FIELD INSPECTION NOTES OF THE DISTRICT FOREST OFFICER,
KUMRAM BHEEM-ASIFABAD AND FOREST DIVISIONAL OFFICER, ASIFABAD (FAC) IN
ASIFABAD DIVISION

Inspected the site on 20.07.2018 & 04.08.2018 proposed area for Diversion of **16.5099 Ha** Forest land for construction of four Laning of NH 363 from Mancherial to Chandrapur from (Length 94.602 from 0.000 Km to 94.602 in favour of DGM (Tech) & Project Director, NHAI, PIU Nirmal falling in Asifabad and Rebbena Ranges along with concerned staff. As per the field verification of the proposed construction of four Laning of NH - 363 is passing through various Reserve Forests, the details of which are as follows.

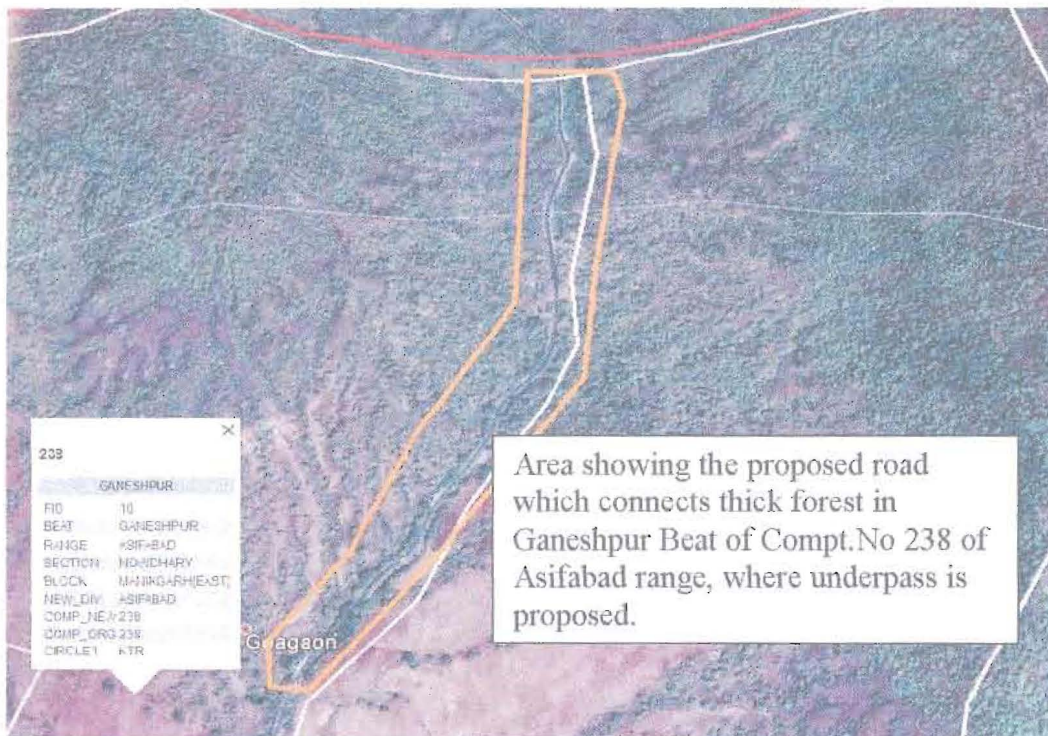
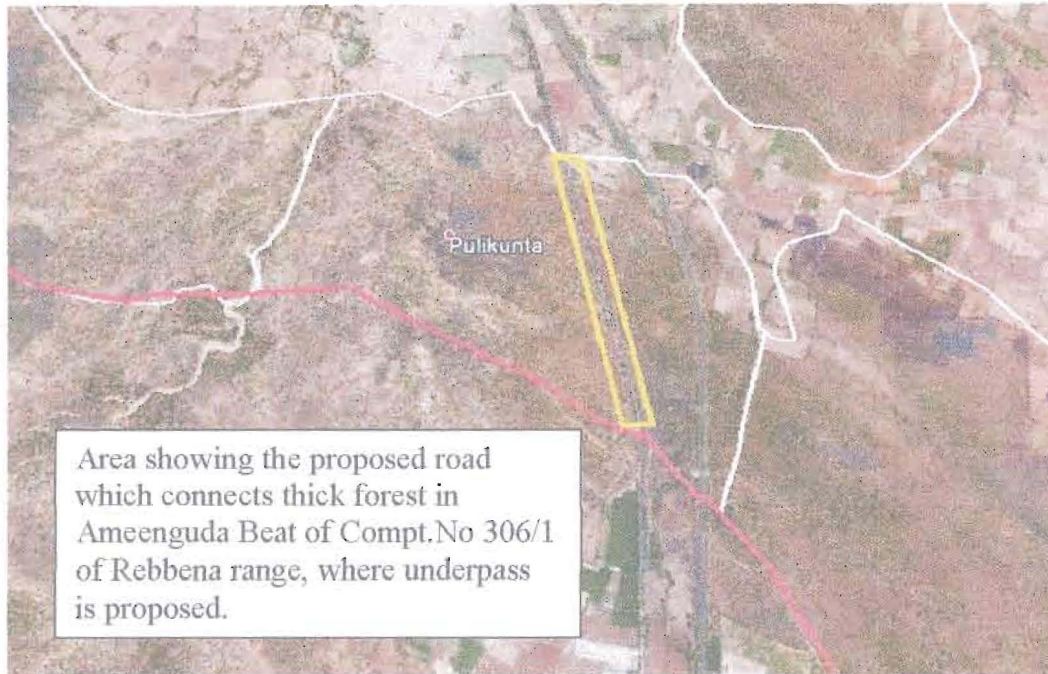
The proposed construction of four Laning of NH 363 is passing through the different Reserve Forests in Rebbena Range, the length is 2057 meters with a width of 5 & 45 Meters and the area required for diversion in Rebbena Range is 3.6285 Ha. The area to be diverted in Compt.No 306/1 of Ameenguda beat has a **connecting patch of thick forest on either side** of the proposed road. This part of road is **crucial for movement of wild animals** from Kagaznagar Division (Shown in image below). As per **guidelines of Wild life institute of India and MoEF&CC (Eco-friendly measures to mitigate impacts of linear infrastructure on wildlife document (attached))**, the length of road through the forest is **between 1 to 2 km**, therefore **one underpass to be provided**. As there are **instances of Leopards and other wild an animal crossing in this area** and it is **mandatory to form the above mentioned underpasses by the user agency**. Further **chain link fencing to be provided for complete RF area to create funnel like structure to guide the wild animals towards the underpass so that accidents can be avoided**, this work has to be **executed by user agency in consultation with DFO**.

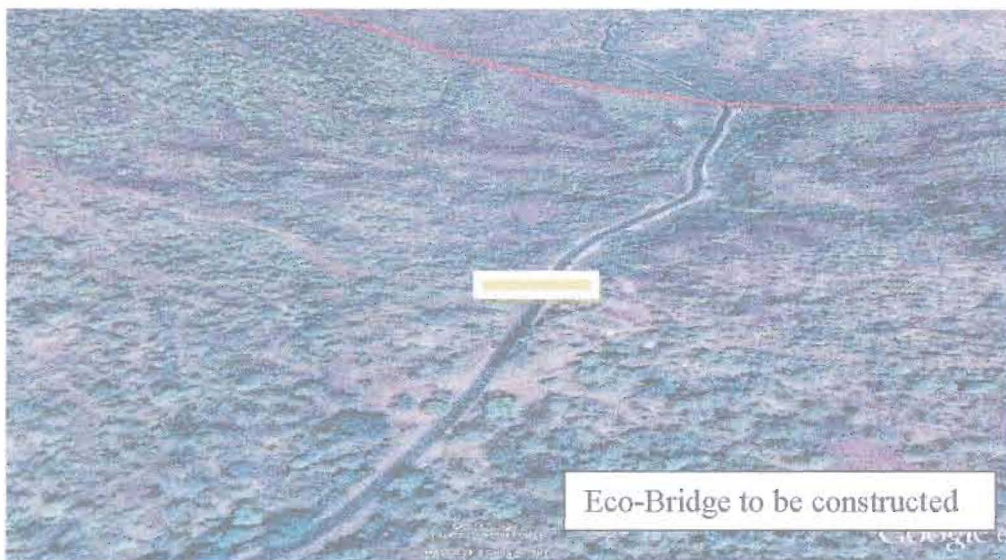
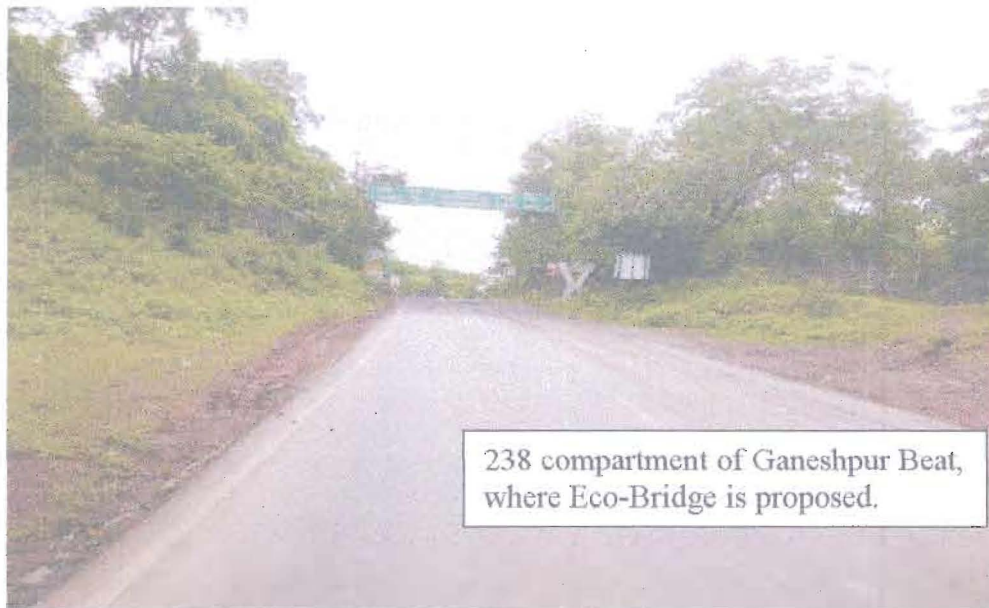
In Asifabad Range, the proposed construction of four Lanning of NH 363 is passing through RF Manighar (East) with the length involving non wild life area of 1700 mtrs with a width of 42 mtrs and the wild life area of Tiger Corridor area of Kawal Tiger Reserve (KTR) with the length of 1367

Mtrs and width of 42.00 Mtrs and the total area required for diversion in Asifabad Range is 12.8814 Ha including tiger corridor area. The patch to be diverted in Compt.No 238 of Ganeshpur beat has a connecting patch of thick forest on either side of the proposed road. This part of road is crucial for movement of wild animals (Shown in image below). As per the guidelines of **Wild life institute of India and MoEF&CC (Eco-friendly measures to mitigate impacts of linear infrastructure on wildlife document, attached)** if the length of road through the forest is between 1 to 2 km, one underpass is to be provided. As this area is forming part of notified **Kawal Tiger Reserve Corridor** and also it is a continuous forest patch connecting forest of Maharashtra state, movement of wildlife is crucial, hence, an Eco-Bridge should be constructed at 19.57209, 79.34492 in compartment 238 of Ganeshpur beat (image attached). Further **chain link fencing is required to create funnel like structure to guide the wild animals towards the underpass to avoid accidents, this work is to be executed by user agency in consultation with DFO.**

Figure 8.1. Underpass configurations suggested for different widths of wildlife corridors. A) 1 km flyover for 1 km wide corridor; B1) or a 750 m underpass or two underpasses of 300 m each (B2) for 2 km wide corridor; and C) 3 underpasses of 300 m each for a 3 km wide corridor.

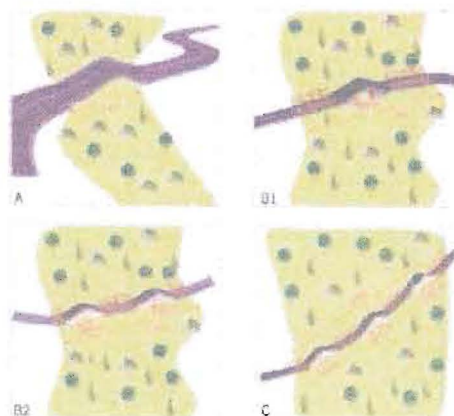
- If the width of the corridor through forest habitat is 1 km or less, the construction of flyovers should be undertaken in such a way that the entire stretch of forest remains connected.

- If the width of the corridor is 1-2 km, one underpass of 750 m should be provided across the landscape. The exact location of the underpass should be based on topographic features of the area and information about customary animal crossing zones. This 750 m stretch of elevated road could also be divided into two parts of minimum 300 m each, located within that corridor. Their location would depend upon the terrain, characteristics of the particular species and its movement patterns.

- If the width of the corridor is 3 km or more, or if the forest landscape is to be dissected by either a new road or the upgradation of an existing road, 300 m underpasses are suggested within every km stretch of the road. The exact location of the underpasses should be based on topographic features, crossing zones, and the particular ecological requirements of the affected species.

Figure 8.3. Diagrammatic representation of isolated and wall-type piers. Source: Adapted from Singh et al. 2012. Illustration by Niharika Saxena.

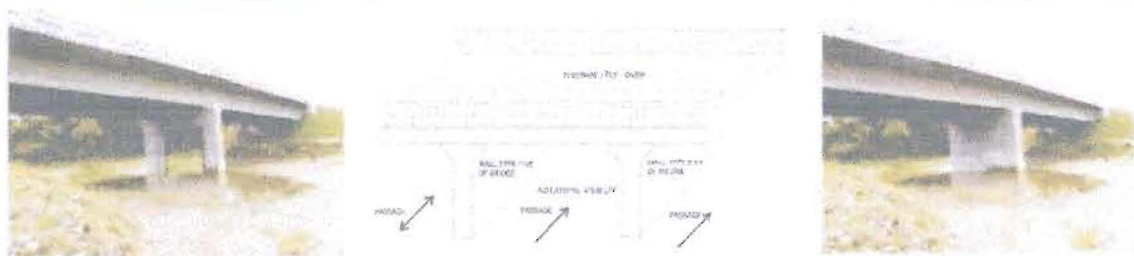
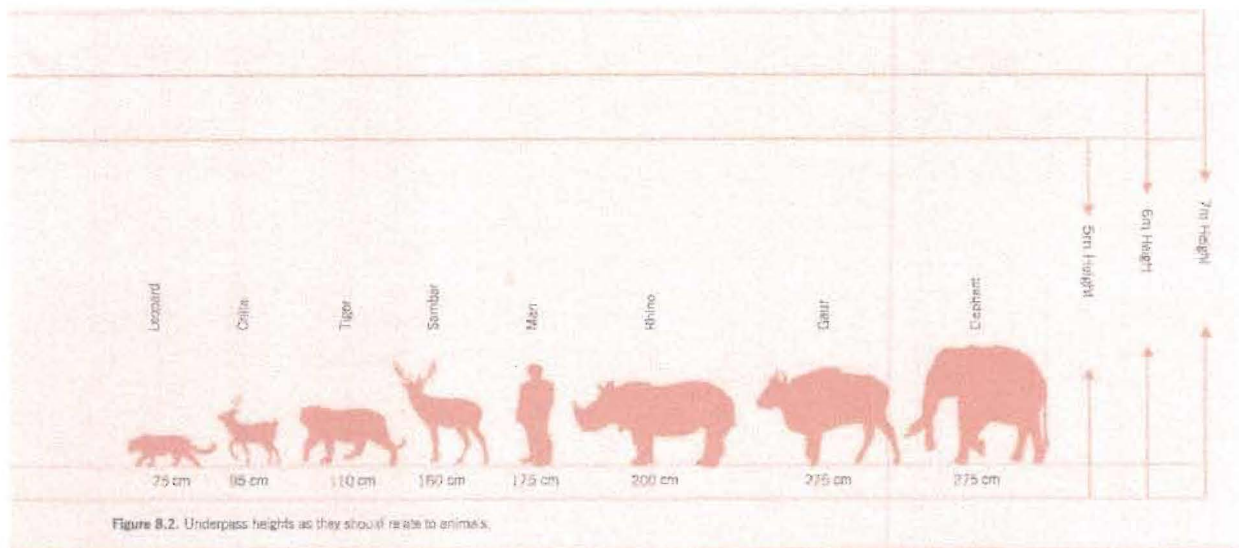
The design of the walls and the piers of an underpass can significantly improve the acceptability of passage structure by animals. Isolated piers are more favourable than wall-type piers: wall-type piers reduce lateral visibility and increase tunnel effects, especially for species that move in groups, such as chital. The inclusion of a cross beam at the top of isolated piers further improves their acceptability. Figure 8.3 shows line drawings and constructed animal underpasses with wall type and isolated piers.
